## **ALERT SERVICE BULLETIN**

**205B-23-76**  
20 October 2023

**MODEL AFFECTED:** 205B

**SUBJECT:** INBOARD STRAP FITTING 212-010-103-101,  
RECALL OF

**Figure 1. Inboard strap fitting 212-010-103-101.**

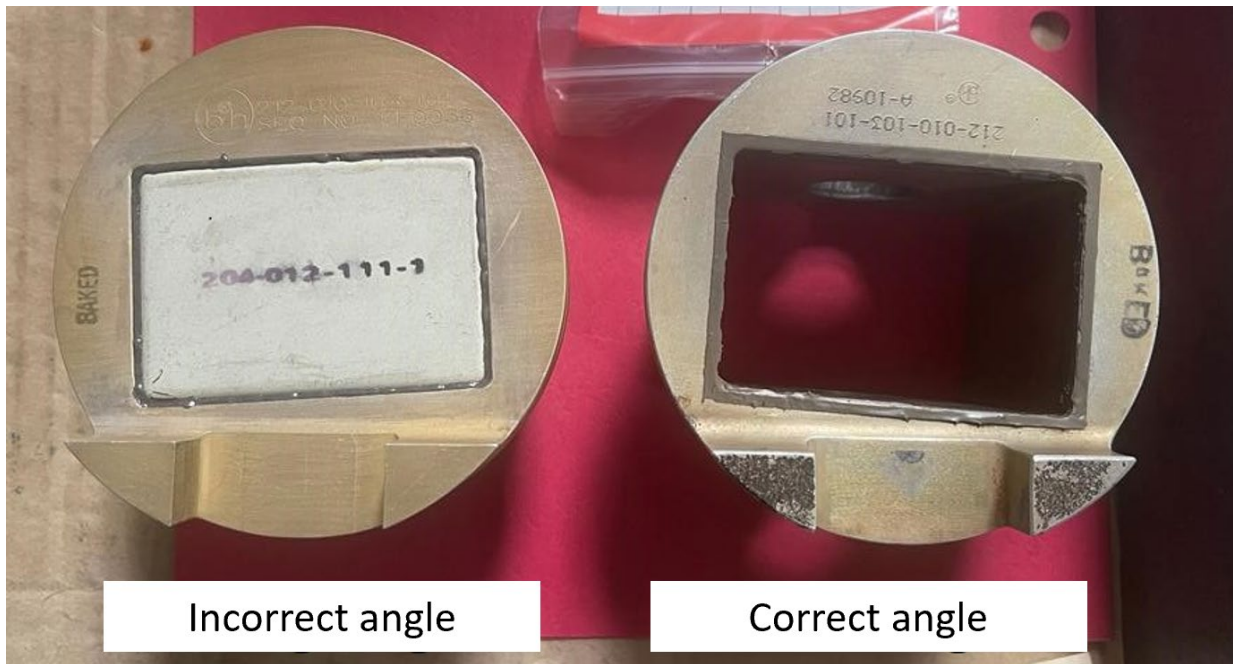
Bell has been informed that some 212-010-103-101 inboard fittings have been incorrectly manufactured with the static stop lugs at an incorrect angle as shown in Figure 1. This ASB requires that the affected fittings be returned to Bell.

1. Review helicopter records and current spare inventory for inboard strap fittings 212-010-103-101 with a serial number ranging from FF0002 through FF0047 inclusively.
2. If affected strap fittings have been installed, replace in accordance with the BHT-212-CR&O chapter 62.
3. Return all defective inboard strap fittings to Bell using the instructions detailed in the WARRANTY section.
4. If an affected inboard strap fitting had to be removed from a main rotor hub assembly, make an entry in the helicopter logbook (if applicable) and historical service records indicating compliance with this Alert Service Bulletin.
